Permit Modification Application

USAADACENFB Fort Bliss Municipal Solid Waste Landfill *Permit 1422*

Revision 1 - December 21, 2011

- A TCEQ Core Data form
- B TCEQ Part I form
- C Redline/Strikeout Copies
 - C-1 – Replacement Documents Summary Table
 - C-2 – Appendix O – Closure Plan [redline]

Figure 1: Rooting Depth Comparison

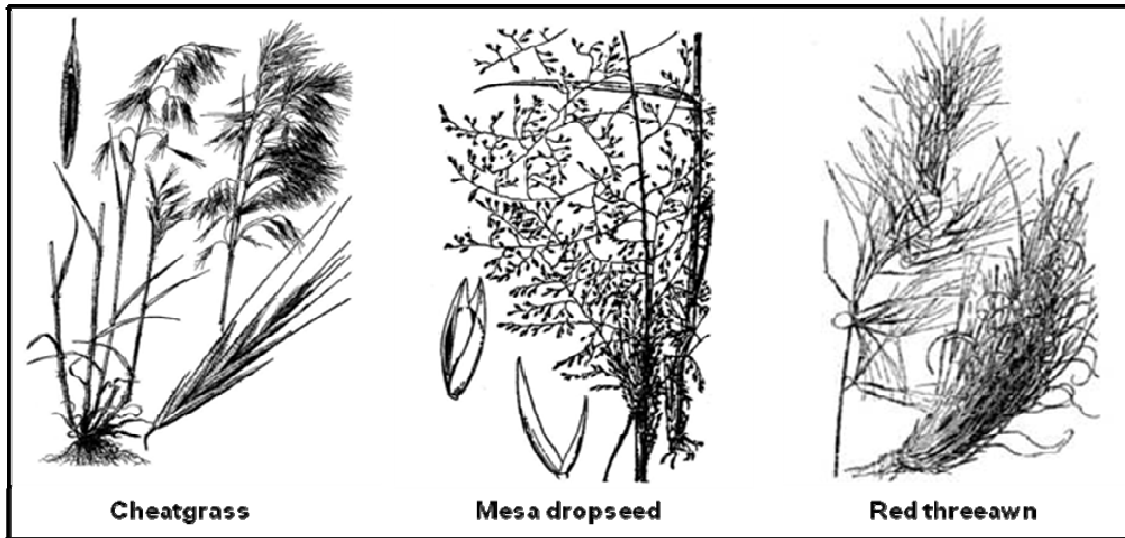
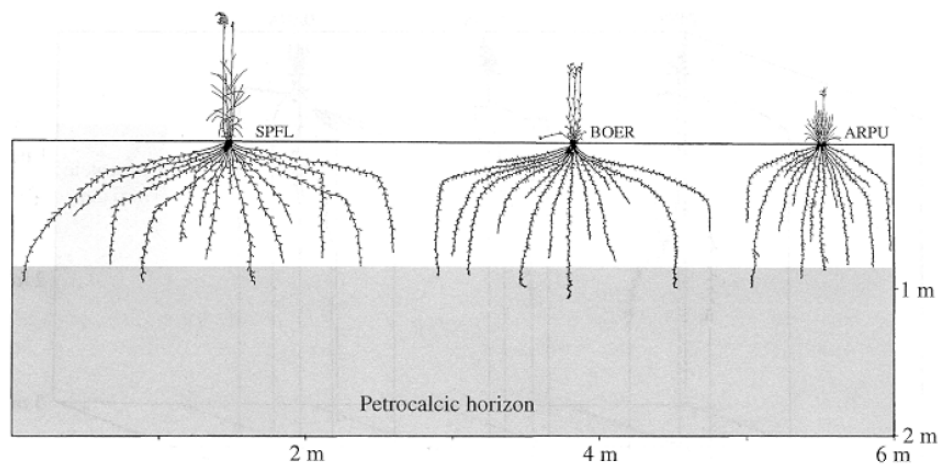
~~The rooting depth of cheatgrass is very similar to the native species of grass found at Fort Bliss as shown in Figure 1.~~

Figure 1. Mesa dropseed and red threeawn rooting system
